Office Action Summary

10/540,639

DETAILED ACTION

Claim Rejections - 35 USC § 103

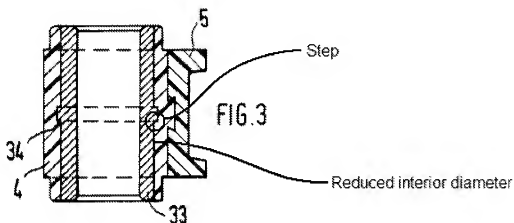
Regarding claim 1, applicant's arguments are directed towards amendments to the claims as well as the perceived absence of a step. The collar (34) qualifies as previously explained and an additional figure has been included to better illustrate the claimed step-like quality of the feature. Applicant added a further limitation of two identical bushings, rather than only one, requiring a new rejection.

Regarding claim 6, applicant argued that Gröger et al lacks a claimed bead. Collar (34) differs from the claimed bead in that it has a rectangular cross-section, rather than an arcuate one, while performing the same function in the same way.
